Before a Board of Inquiry
Transmission Gully
Notices of Requirement and Consents

Second statement of rebuttal evidence of Michelle Kathleen Malcolm
(Water Quality) for the NZ Transport Agency and Porirua City Council

Dated: 16 February 2012

Graph 1 Pauatahanui Stream

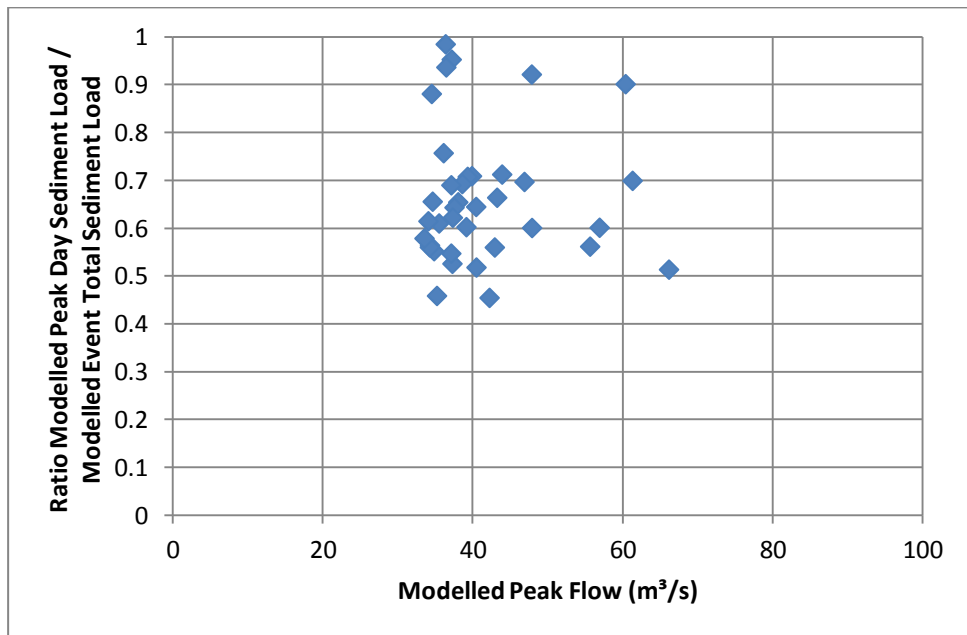
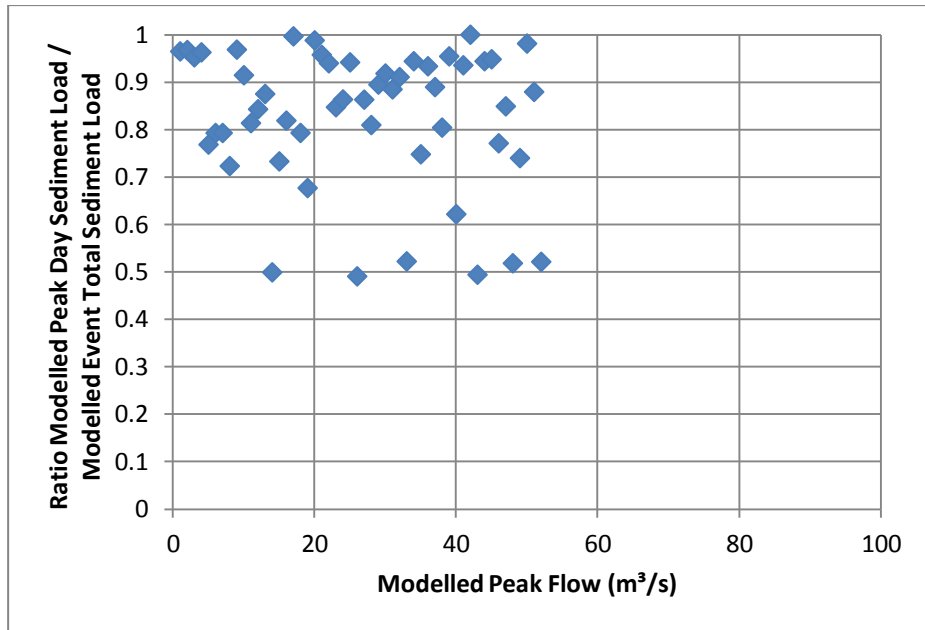
- 42 In bullet point 9 Dr Hicks discusses the daily time step used to develop the rating curves. I agree this method of developing the rating curve is likely to lead to an underestimation of sediment yield, because even though most of the events in the catchments are less than 24 hours, many are spread over longer than one calendar day. Graphs 1, 2 and 3 below illustrate for the Pauatahanui, Porirua and Horokiri catchments that, for days of consecutive rain, approximately 70% of the load is modelled in the peak day, with the remaining sediment load spread over the preceding and following days. This would lead to up to a 30% underestimation of event loads.

43 This underestimation of event sediment yield applies to both the 'with' and 'without' Project scenarios. Further harbour modelling has been undertaken to test the effect of this.

**INVERTEBRATE ABUNDANCE AND BASELINE THRESHOLD SEDIMENT DEPOSITION
10 year event in Duck/Pauatahanui, northerly wind, (+30% sediment), 3 days post peak of storm**

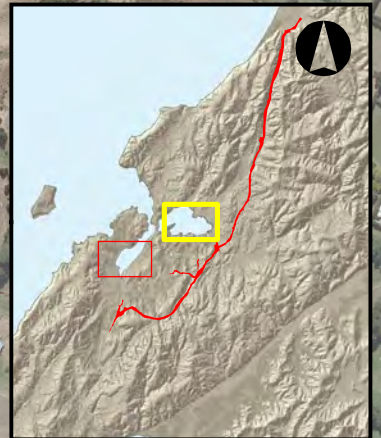
45 The results are presented in **Appendix B**. **Dr De Luca** has reviewed these results and advised that the baseline deposition patterns appear relatively similar to that previously assessed (**Dr De Luca's** Figures 21 and 35, Appendix B). However, the "with Project" scenario shows a different pattern of sediment deposition

above ecological effects thresholds (**Dr De Luca's** Figures 10 and 33, Appendix B).

- 46 In the 30% more sediment "with Project" scenario significantly less intertidal benthic habitat receives sediment above threshold depths (0.2 ha compared to 3.9ha) and similar areas of subtidal benthic habitat affected (2.0 ha compared to 2.4 ha) (see Table 2 below). I understand that **Dr De Luca** concludes that the +30% sediment scenario has less ecological effects (negligible) than that previously modelled and assessed. **Mr Roberts** has advised me that this result is likely to be due to the "with Project" sediment depositing on areas already affected by the higher baseline sediment deposition.
